To: Brad Sedgwick
From: Pat O’Mahony, Associate Planner; 910-341-0189
CC: File;
Date: 10/13/2020
Re: Nourish NC TRC Rev. 1

The following is a list of comments for review from planning regarding the project. Please provide your corrections as listed below. A staff summary of comments:

Project Name: **Nourish NC**

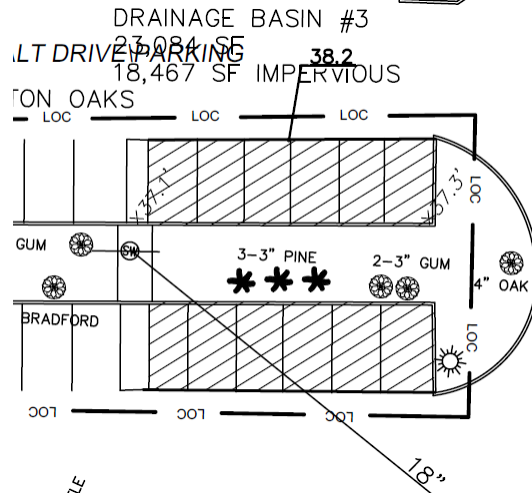
- 18 shrubs are required in streetyard, 8 are shown.
- Show streetyard calculations with a multiplier of 18.
- Minimum streetyard width for O&I-1 is 9'.
- Clarify the area below, plantings may be required at the end of the parking aisle.

BASE INFORMATION:

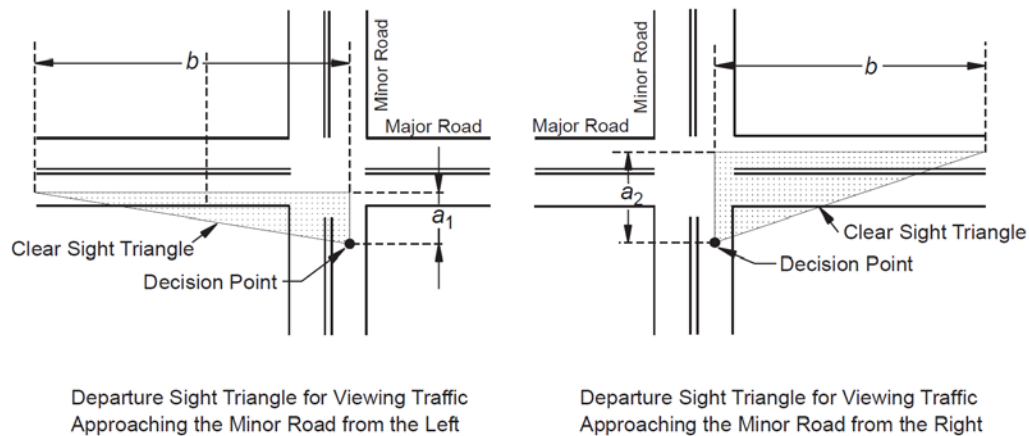
- Coordinate with Engineering division for any variance to the technical standards.
